HISTORIC AND DESIGN REVIEW COMMISSION

March 01, 2017

HDRC CASE NO: 2017-076
ADDRESS: 817 NOLAN / 705 N PINE
LEGAL DESCRIPTION: NCB 549 BLK 9 LOT 5&6
ZONING: R-6 CD H
CITY COUNCIL DIST.: 2
DISTRICT: Dignowity Hill Historic District
APPLICANT: Willie A, JR & Guadalupe I Francois
OWNER: Willie A, JR & Guadalupe I Francois
TYPE OF WORK: 817 Nolan - Construction of a rear accessory structure, fencing, site work, exterior modifications to the existing wraparound porch / 705 N Pine – Fencing and landscaping

**Historic and Design Review Commission
Design Review Committee
Report & Recommendation**

Garage & Shed Elevation

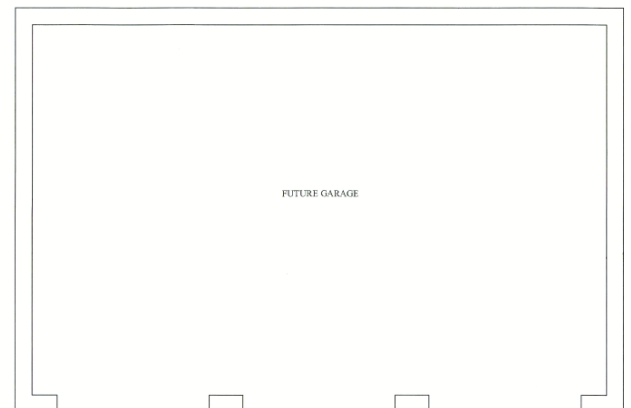
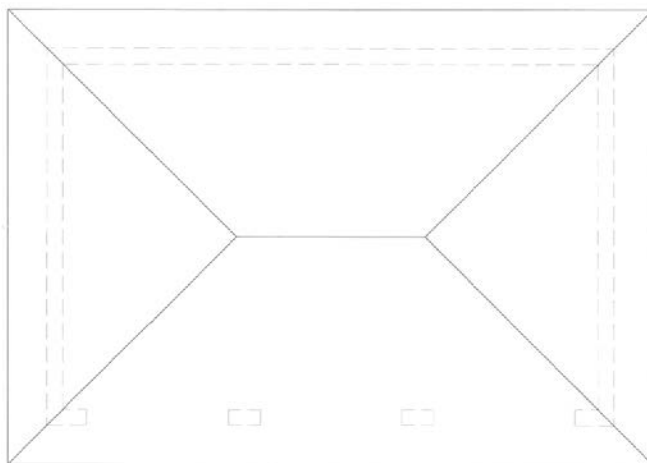
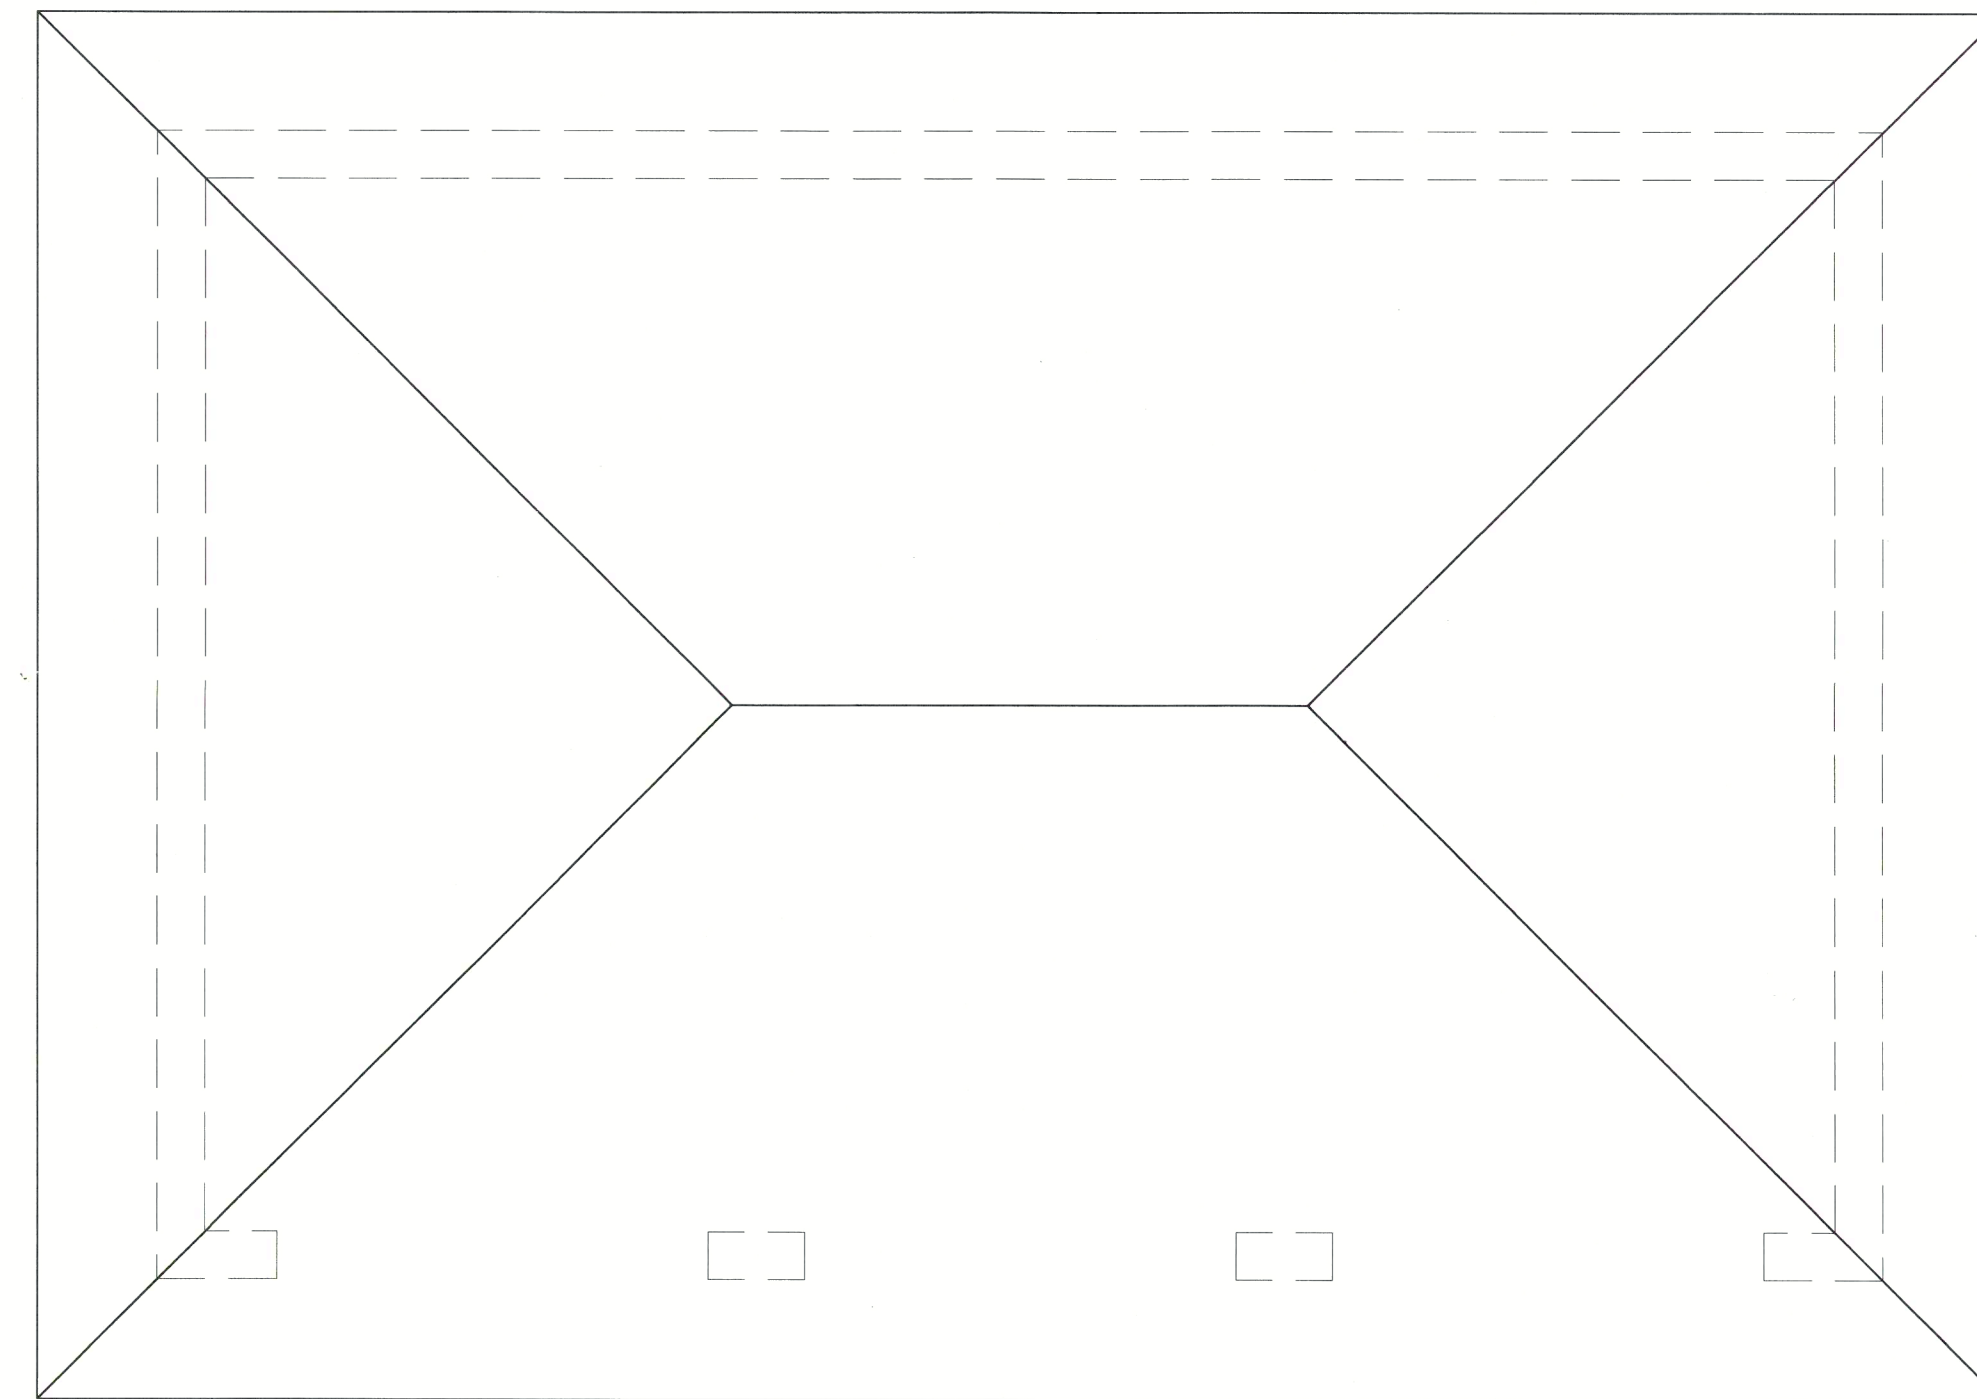
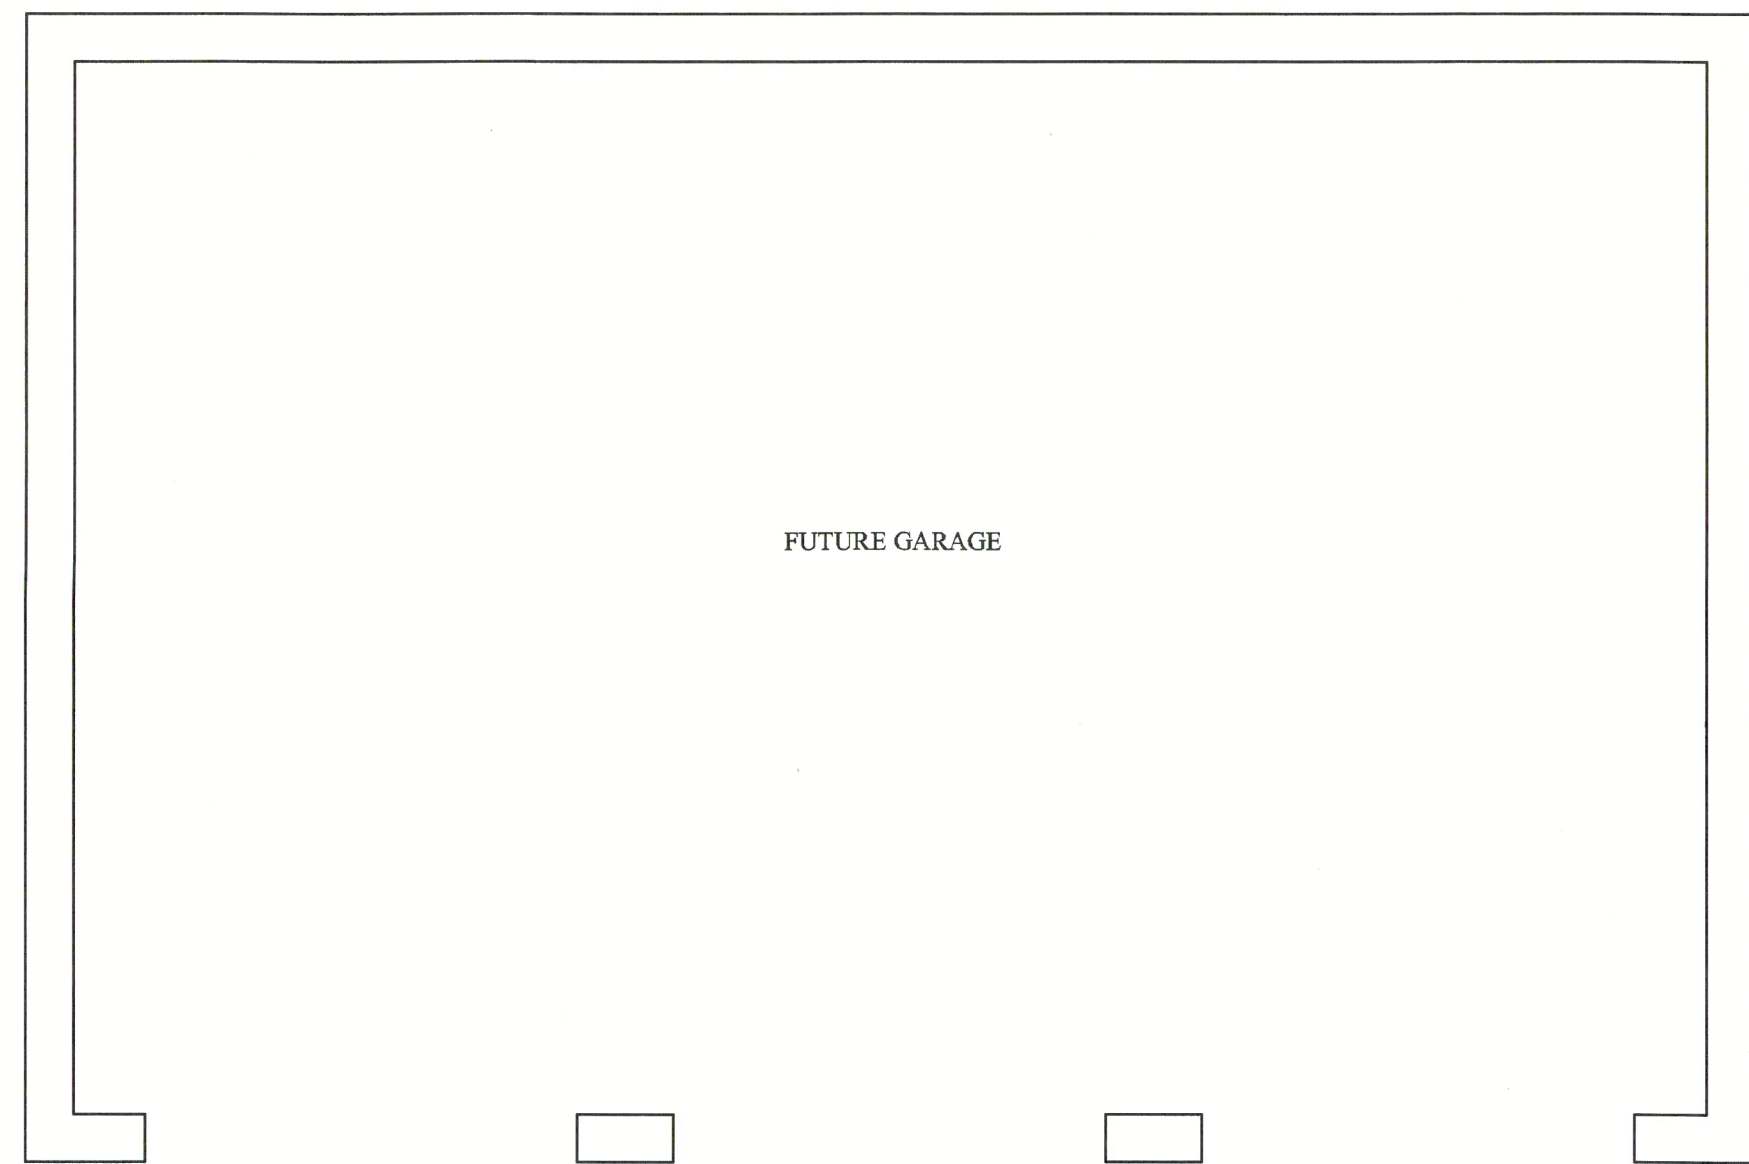
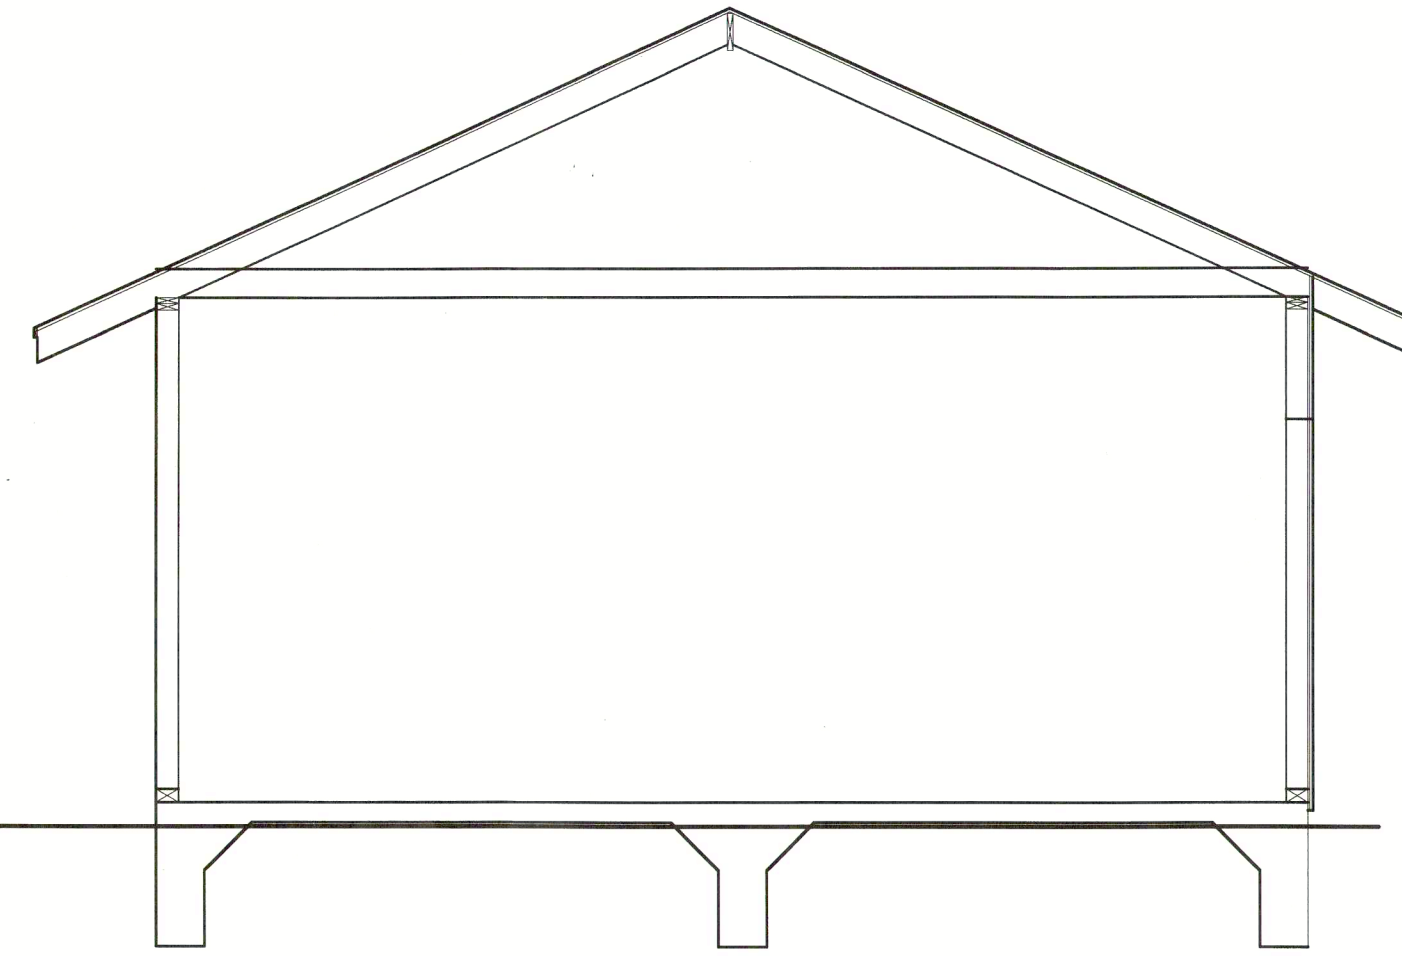
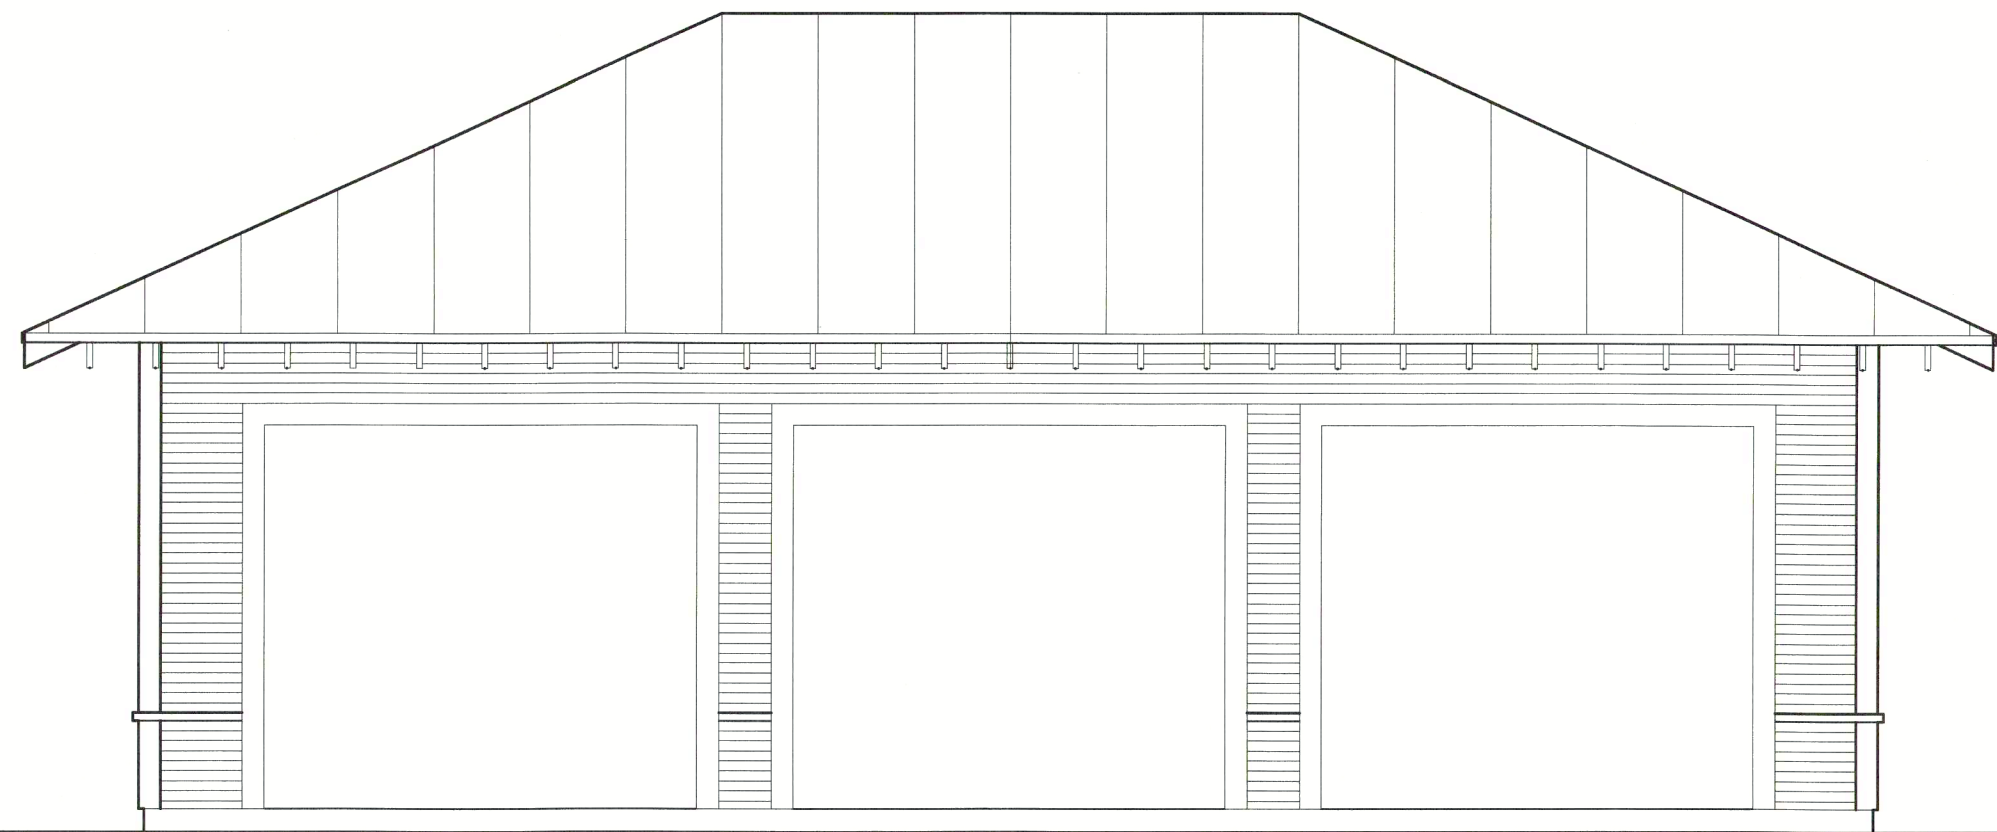
- b. **REAR GARAGE & STORAGE STRUCTURE** – At the rear of the lot at 817 Nolan, to the rear of the primary historic structure, the applicant has proposed to construct a garage to accommodate three vehicles as well as an attached storage shed. The applicant has proposed an overall footprint of approximately 1,100 square feet. The Guidelines for New Construction 5.A. states that garages and outbuildings should be visually subordinate to the primary historic structure on the site, should be no larger in plan than 40 percent of the primary historic structure, should relate architecturally to the primary historic structure and should feature windows, doors and garage doors that feature proportions and materials similar to those found historically in the district. The applicant's proposal is consistent with the Guidelines through the use of complementary materials and architectural detailing. The applicant has proposed to install wood garage doors.

ARE APPROPRIATE AS WELL AS LOCATION AND MATERIALS.

East View of Roof – Version 2

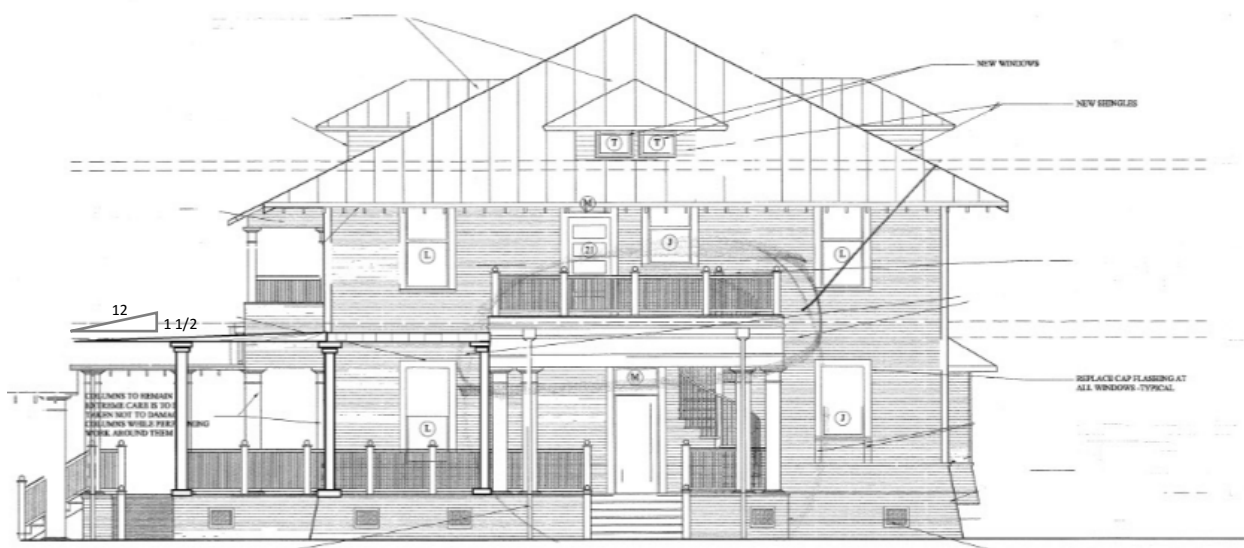
- h. **PORCH ROOF** – The applicant received approval on December 3, 2014, for the construction of a porch to the east façade of the primary historic structure. At this time, the applicant has proposed to construct a roof to cover portions of the historic porch, which were never covered, as well as to construct roof over the recently completed side porch. Per the Guidelines for Exterior Maintenance and Alterations, 7.B.iv., new elements and details that create a false sense of history should not be added to historic structure. Staff finds that the installation of a single story porch roof would both create a false sense of history and be architecturally inappropriate for a historic

OF WRAP AROUND PORCH; (PORCH WAS ADDED TO STRUCTURE). THE INSTALLATION OF A NEW PORCH ROOF IS NOT APPROPRIATE. THE WEATHERING OF THE NEW PORCH IS A RESULT OF ITS CONSTRUCTION. THE CONSTRUCTION OF A ROOF WOULD NEGATIVELY IMPACT THE MASSING OF THE HISTORIC STRUCTURE; IT IS A RADICAL TRANSFORMATION.

705 N. Pine Property Line

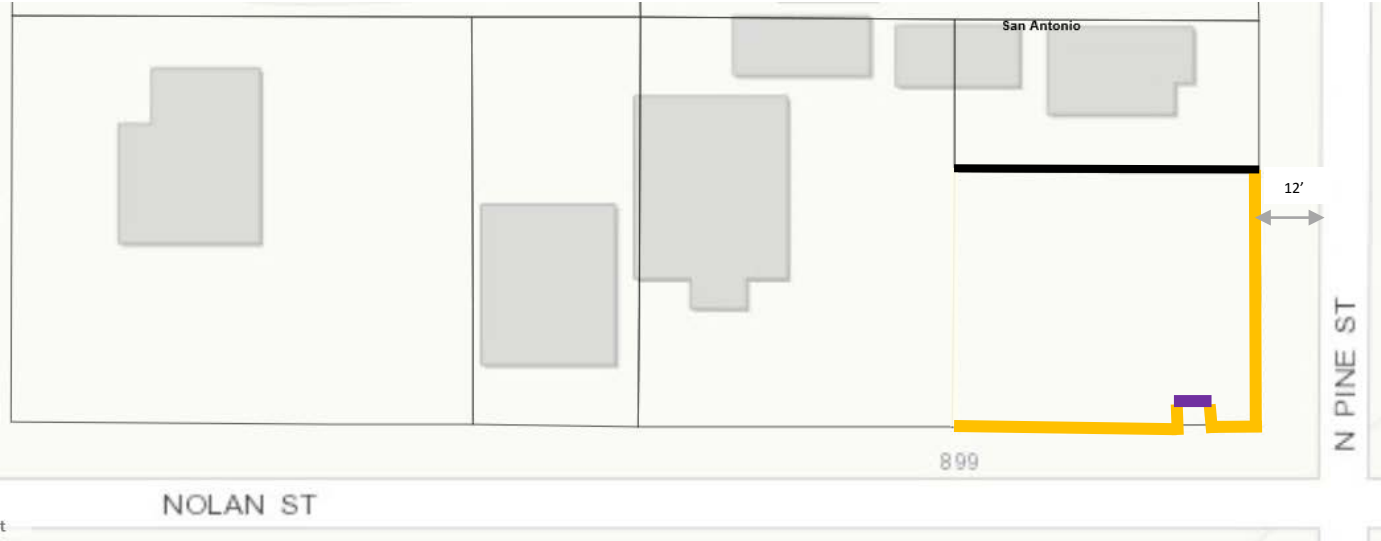
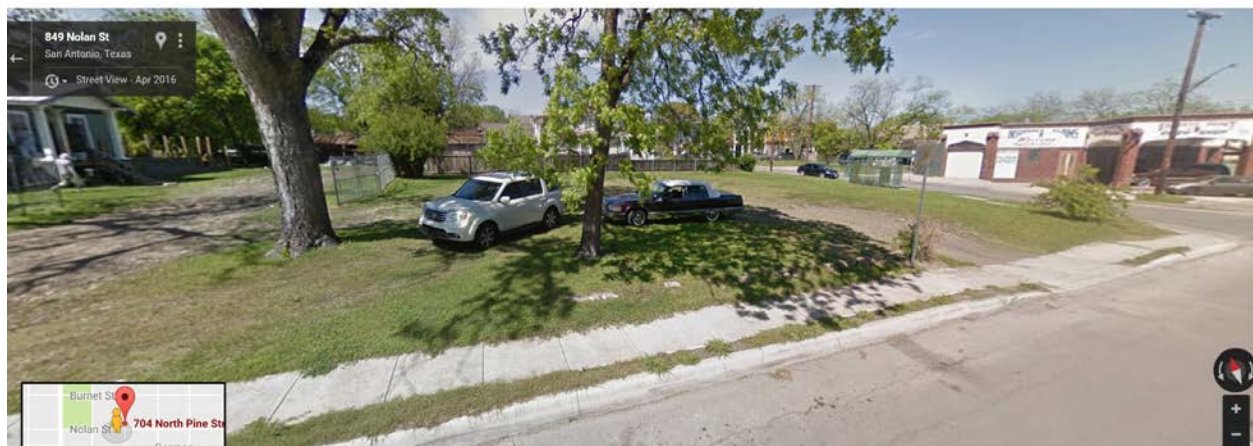
- i. FENCING – The applicant has proposed to enclose both lots, 817 Nolan and 705 N Pine with fencing. The applicant has proposed to install a six foot tall wood privacy fence to extent along the western property line to stop at the front façade of the property, a five foot tall iron fence along the public right of way at Nolan, a five foot tall iron gate and five foot tall rolling iron gate for the proposed sidewalk and driveway. At the lot line, the applicant has proposed to install a five foot tall wood post and wire fence and wood gate to extend along both Nolan and N Pine.

- j. FENCING – The Guidelines for Site Elements 2.B. states that fencing should appear similar to those found historically throughout the district in regards to transparency, scale and character, should be located where historically a fence would have existed and should not exceed four feet in height. Staff finds the proposed height and locations of the proposed fencing inappropriate. Historic fences throughout the Dignowity Hill Historic District do not feature recessed gates.

COMMENTS/CONCERNS: MG: PROVIDING ADDITIONAL INFORMATION

- i. That the applicant install square columns on the proposed open air porch to complement those of the primary historic structure.
- ii. That the proposed front sidewalk and replacement steps feature a width consistent with sidewalks and steps found historically in Dignowity Hill.
- iii. That the applicant install fencing that does not exceed four feet in height except for the proposed privacy fencing.
- iv. That all gates be flush with perimeter fences.
- v. That the applicant submit fencing details to staff noting a height of four (4) feet and overall design.
